## **SERVICE BULLETIN**

**TO** : EC130 Helicopter Owners/Operators with STC  
SR01373SE installed  
**FROM** : FDC/aerofilter Engineering  
**SB NUMBER** : SB.FDC.EC130.0004  
**ORIGINAL SB NO.** : SB EC130-001  
**CATEGORY** : Mandatory Service Bulletin  
**EFFECTIVITY** : EC130 equipped with STC SR01373SE  
**DATE** : July 12, 2005

### **FILTER SEAL ELEMENT**

**FIGURE 1: Seal to be removed  
(Looking aft)**

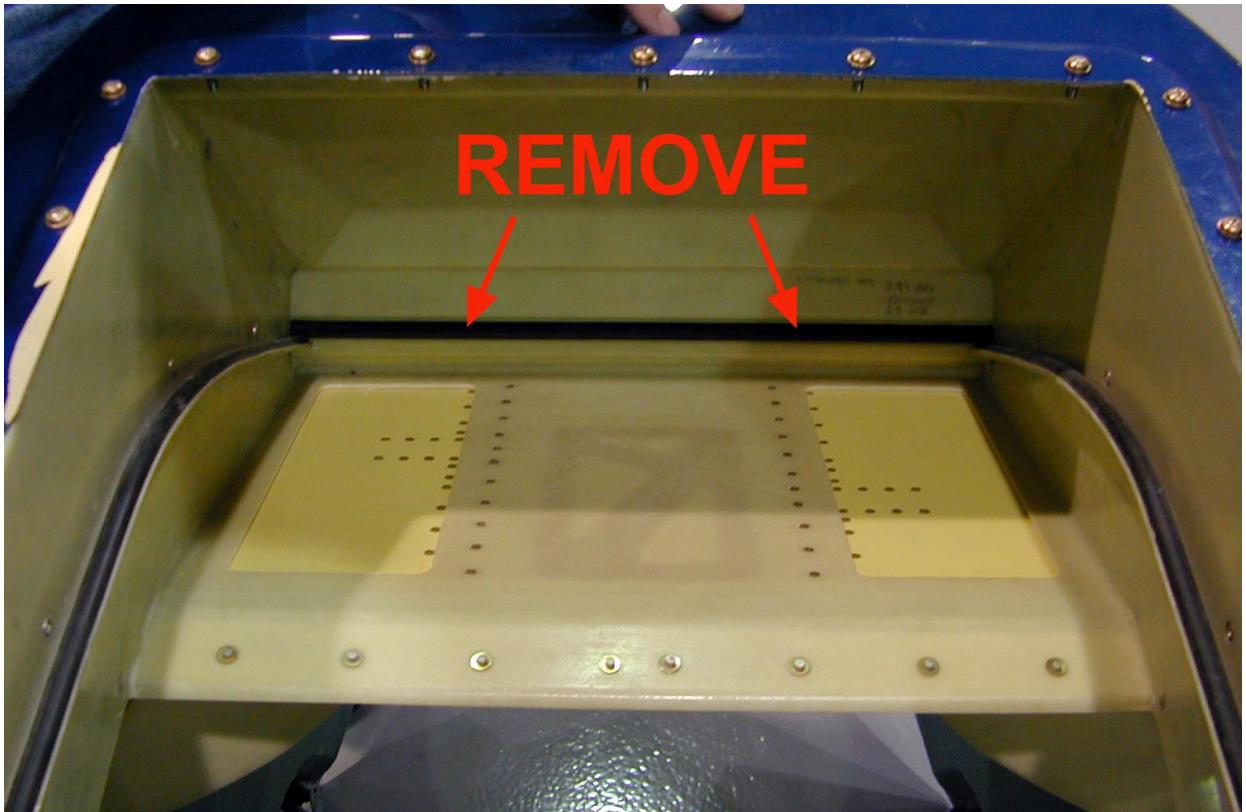
A recent inspection revealed debonding of the aft filter element seal attached to the upper housing. Total time since installation of the filtration system was approximately 1300 hours. It is not clear what initiated the debond. If this seal detaches, it may be ingested into the engine causing damage and possible engine failure. However, as a precaution, this requirement for removal is being issued until a more permanent solution is available.

- (1) Remove the filter element from the upper housing.
- (2) Cover the engine to prevent debris from falling into the engine inlet.
- (3) Carefully peel the aft seal from the upper housing – See Figure 1, Page 3.
- (4) Remove any debris/residue remaining on the duct.
